ORCHARD HILLS NORTH
STAGE 1
SUBDIVISION WORKS CERTIFICATE
PROPOSED LOT, ROAD AND DRAINAGE WORKS
DA 23/0969

WORKS AS EXECUTED AS SHOWN IN RED
NAME: - CRAIG S LONARD
SIGNATURE: *Craig S Lonard*
CAPACITY: - REGISTERED SURVEYOR #8800
DATE: 17.04.2025
CONTACT: ADMIN@HOGANCO.COM.AU

ORCHARD HILLS NORTH
STAGE 1 CADDENS ROAD
COVER SHEET

PLAN RW 13
SCALE 1:200

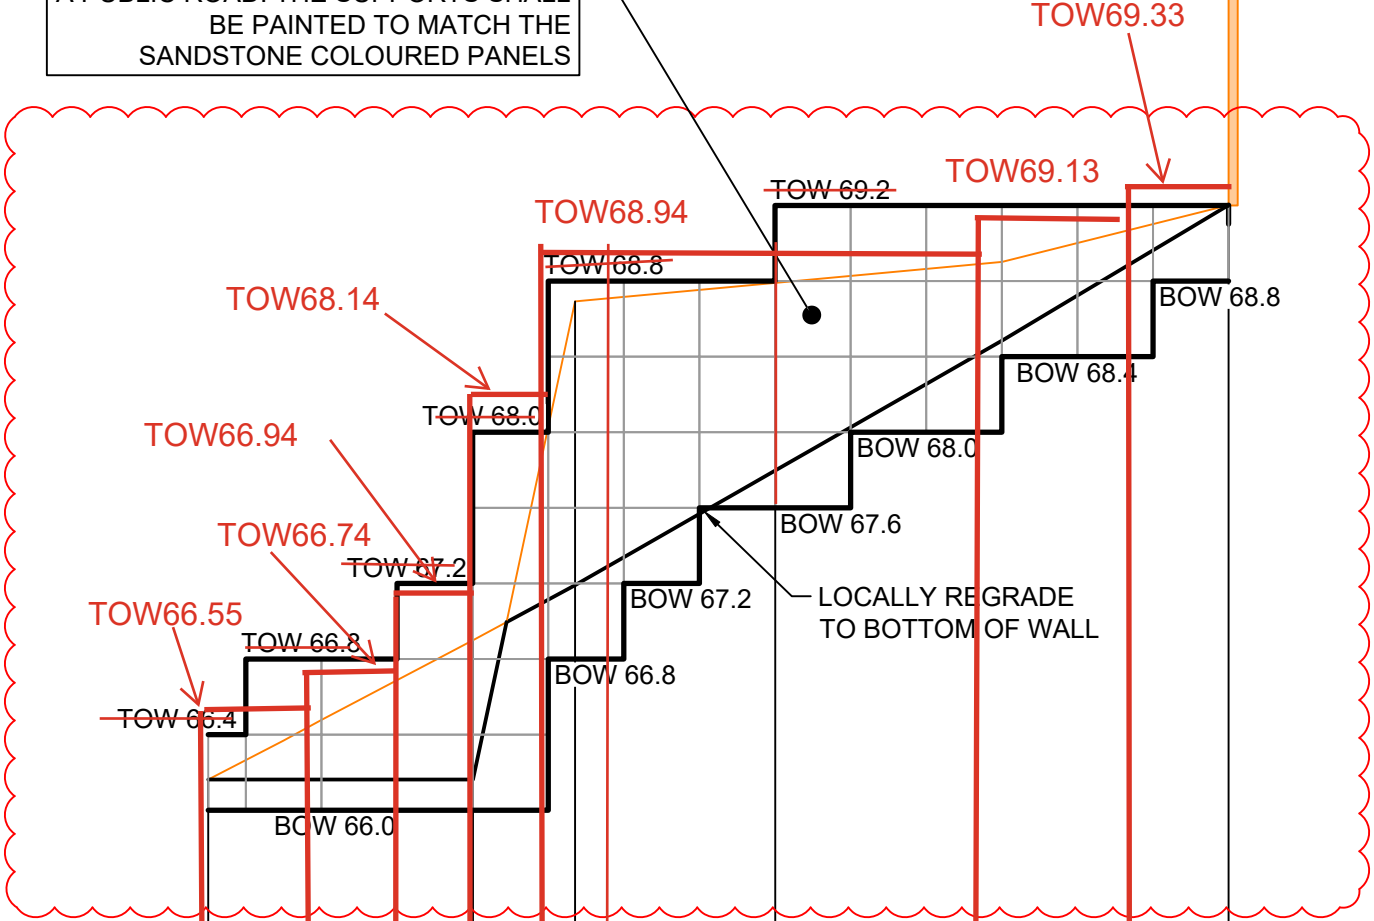
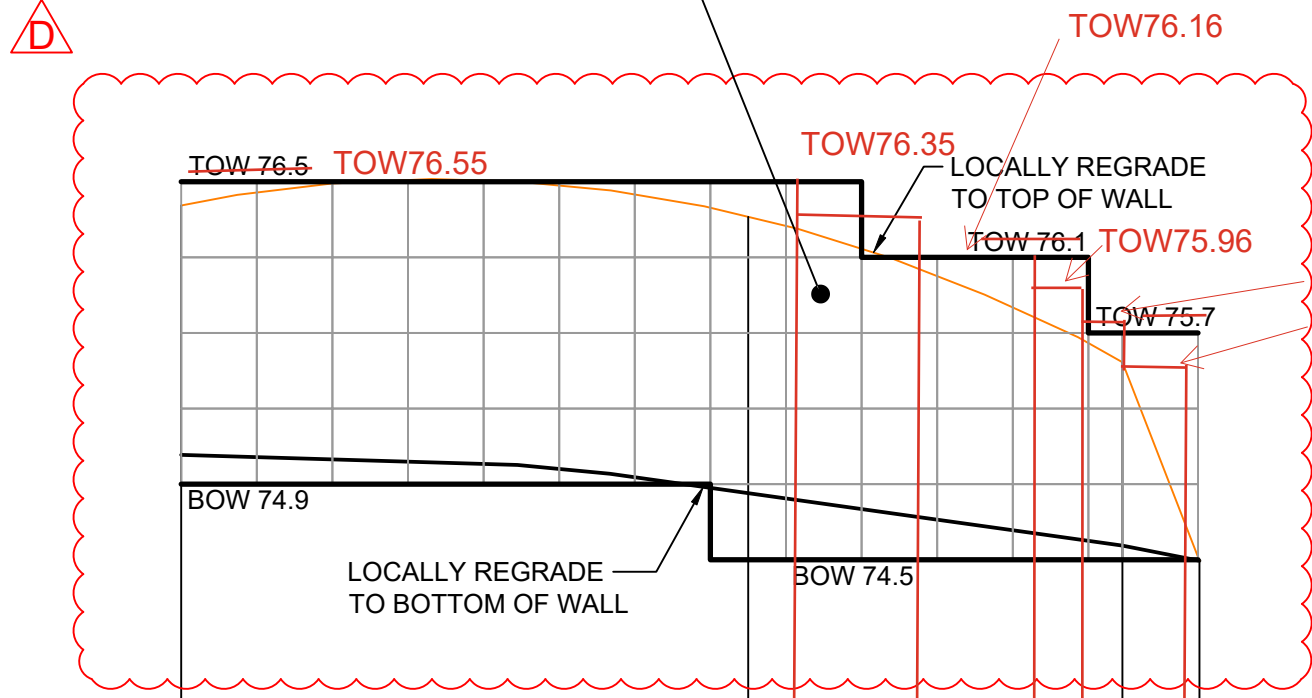
ALL WAE LEVELS FOR RET WALL 13 UPDTAED 29.05.2025

PLAN STAGE 3 RW 1
SCALE 1:200

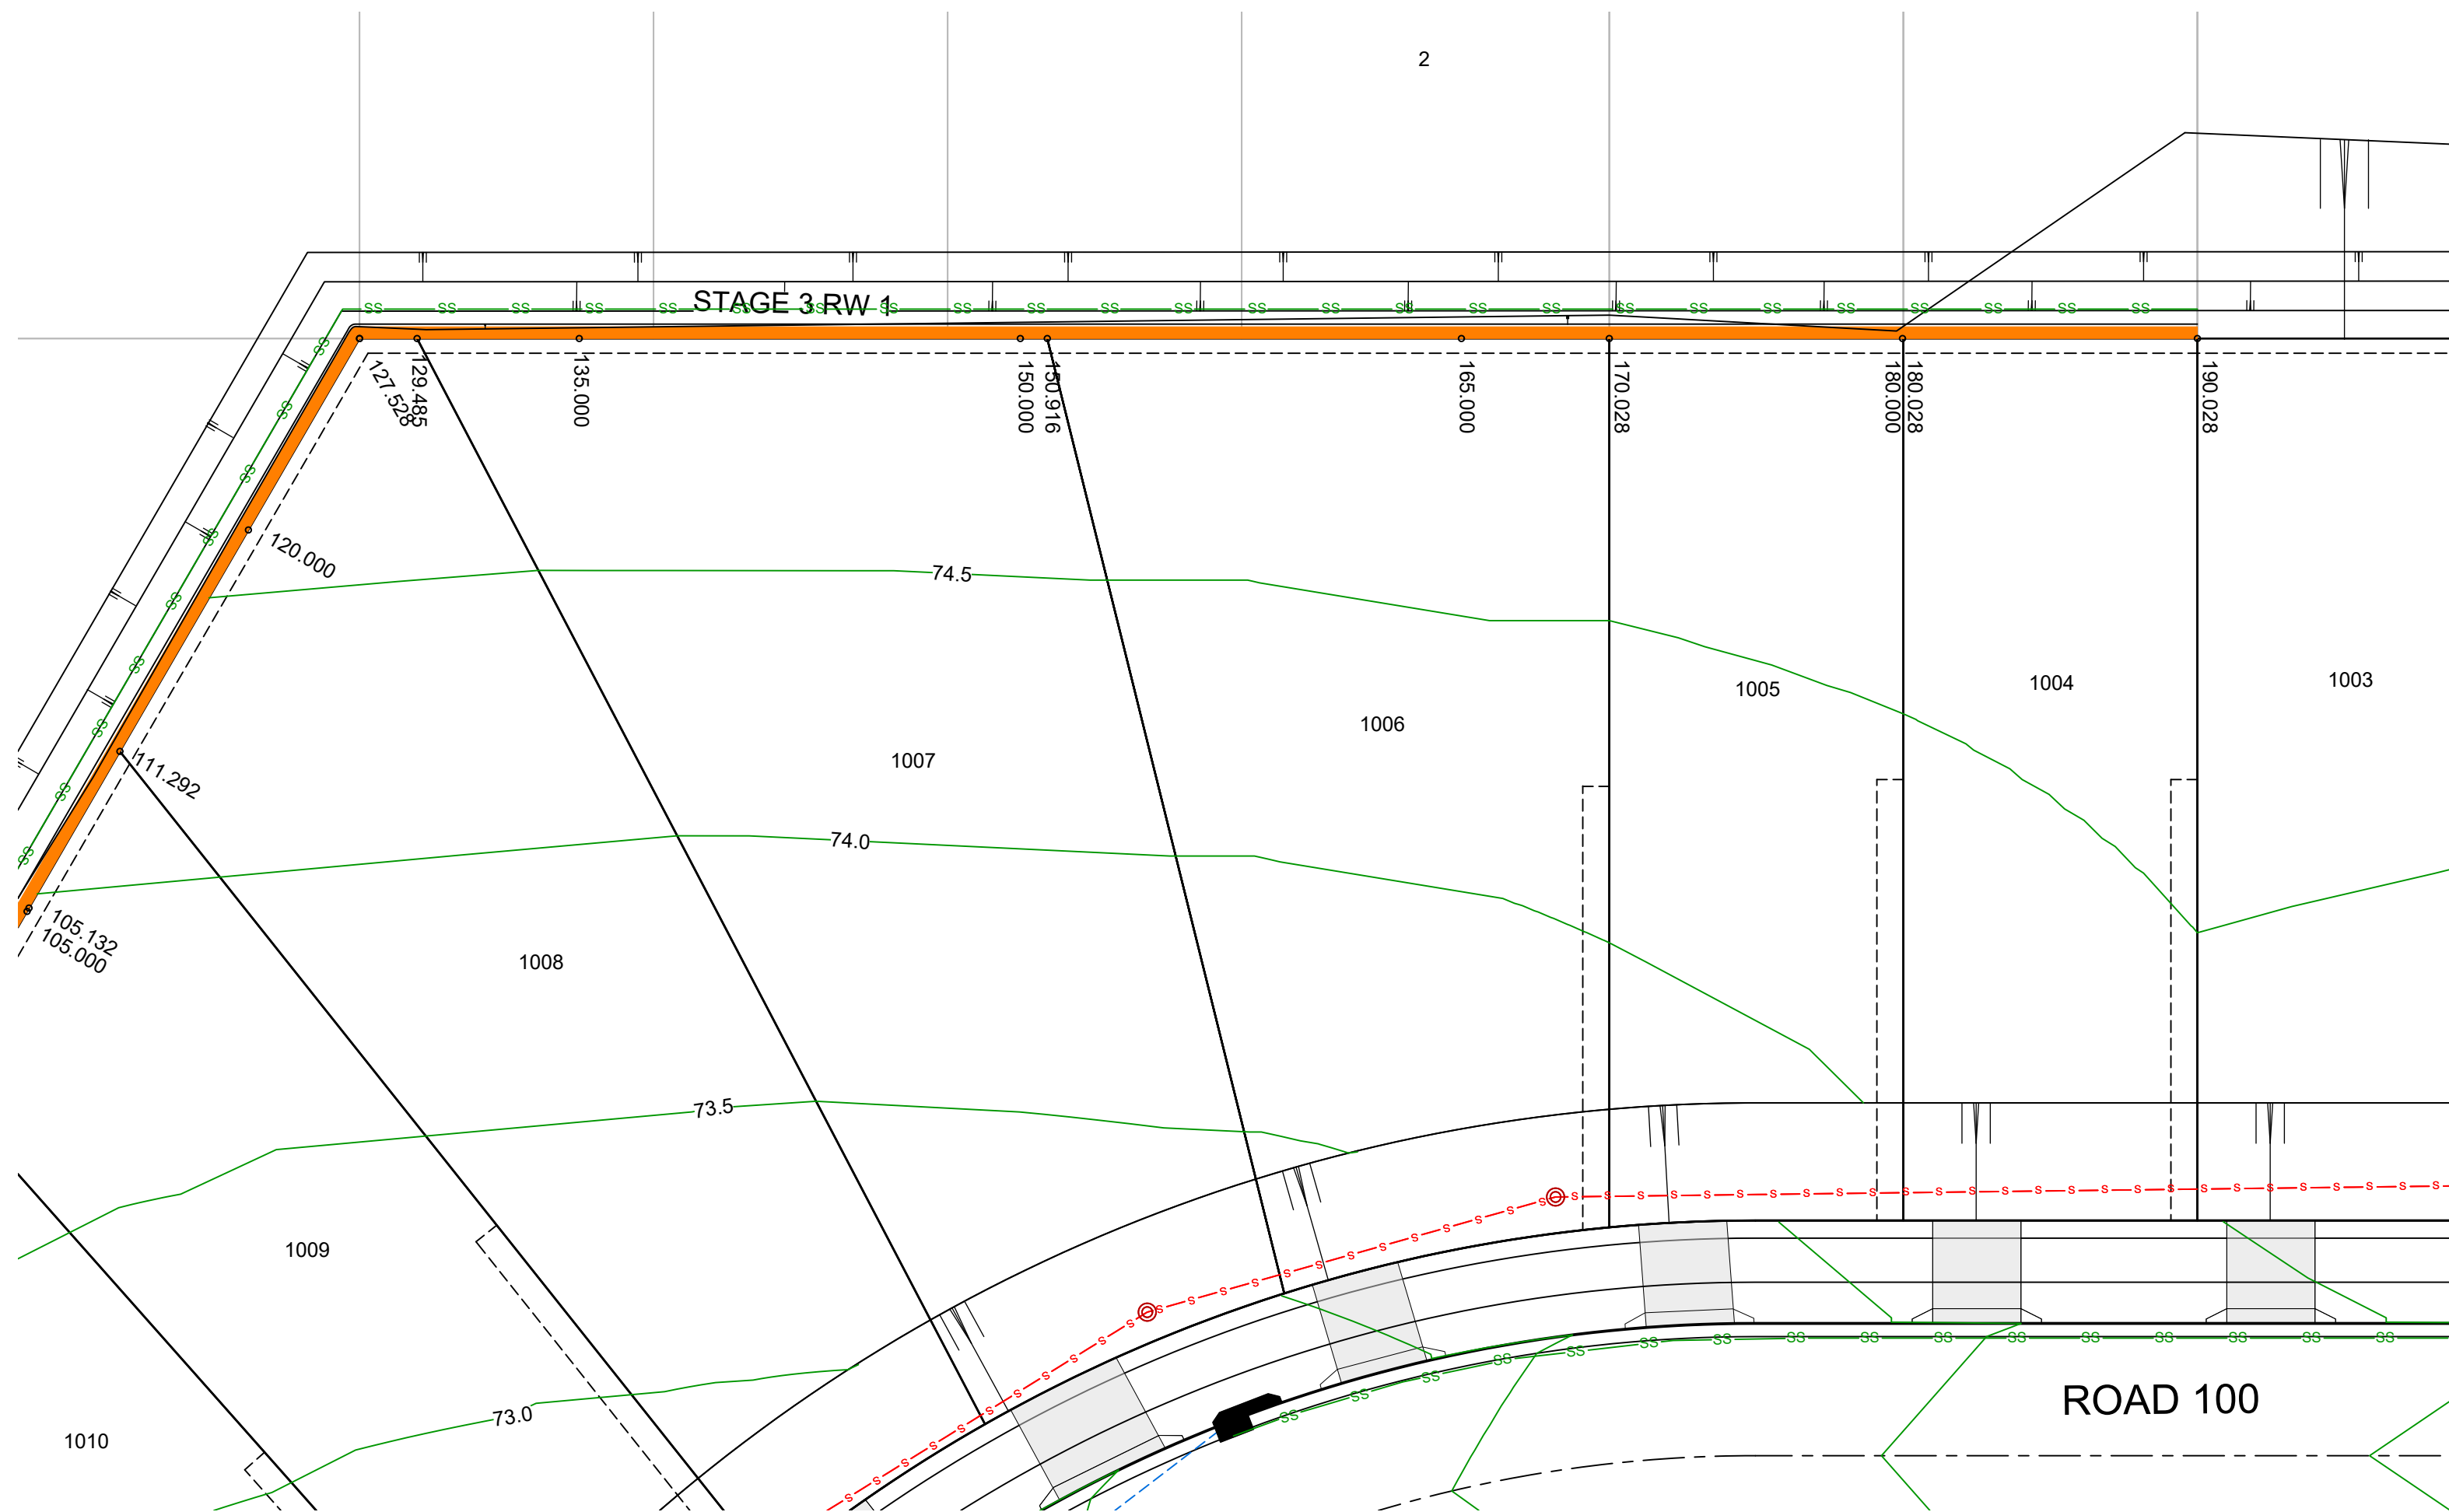
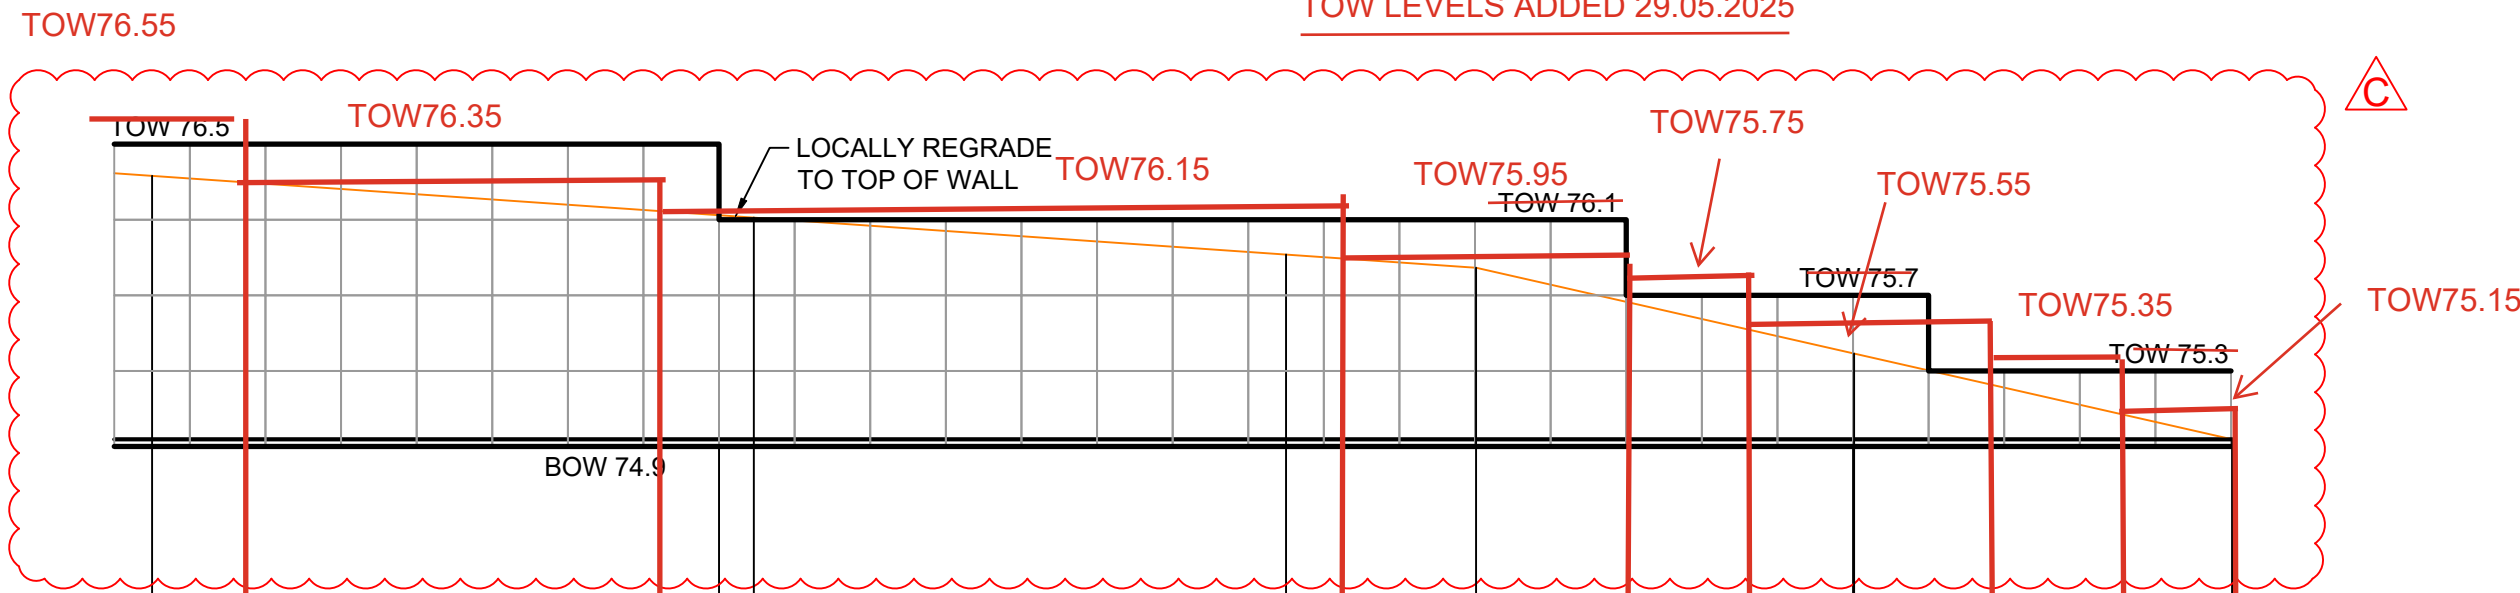
TOW LEVELS ADDED 29.05.2025
